South Texas Project
Units 1 & 2
Docket Nos. STN 50-498, STN 50-499
NRC Question Responses

620.0 HUMAN FACTORS ENGINEERING BRANCH

620.2 Provide the following information and clarification regarding your summary report for the Detailed Control Room Design Review (DCRDR) submitted April 12, 1984:

Figure 620.2-2

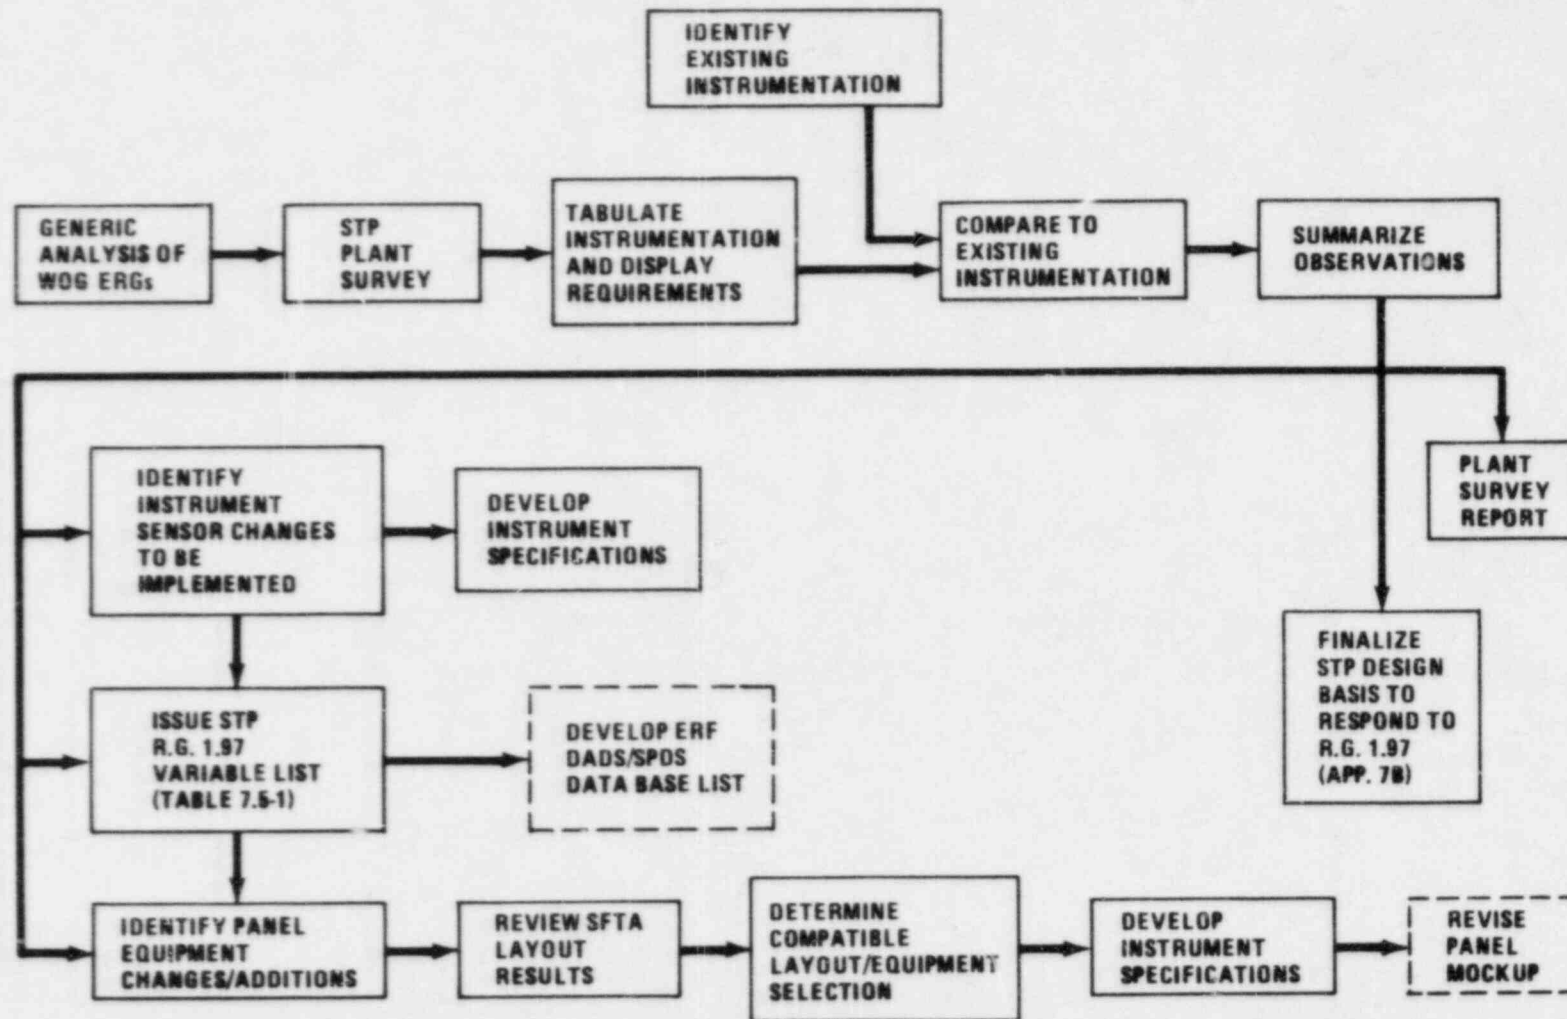
- b. Verify that an objective comparison of independently determined display and control requirements, as determined by function and task analyses has been made with the control room inventory to identify missing controls and displays as required in Supplement 1 to NUREG-0737, and summarize the results of this comparison.

In parallel with the STP CRDR SFTA efforts, STP performed an analysis to address post accident monitoring requirements to respond to Regulatory Guide 1.97. A flow chart of the STP Regulatory Guide 1.97 implementation process is shown in Figure 620.2-2. This was accomplished by performing a task analysis based on the WOG ERGs to identify variables necessary for implementation of the guidelines. This analysis was applied to the STP specific design through a plant survey of the STP design documents. The STP specific analysis is summarized in STP FSAR Appendix 7B. The analysis itself identified, in addition to the variables necessary for implementation of the ERGs, variable display requirements including range, accuracy, qualification, redundancy, recording needs, and operator task utilization. These requirements were compared to existing STP instrumentation to determine required design changes. These changes were incorporated in the revised main control panel mock-up and were utilized in the CRDR SFTA validation. This instrumentation is summarized in FSAR Table 7.5-1.

The Regulatory Guide 1.97 implementation process included a comparison of the display or monitoring requirements, as defined by the STP design basis to respond to Regulatory Guide 1.97, to the main control panel equipment. The monitoring requirements are stated in terms of range, accuracy, and Regulatory Guide 1.97 category which in turn defines instrumentation qualification, redundancy, and display and/or recording requirements. This comparison was performed and documented in an STP Regulatory Guide 1.97 plant survey.
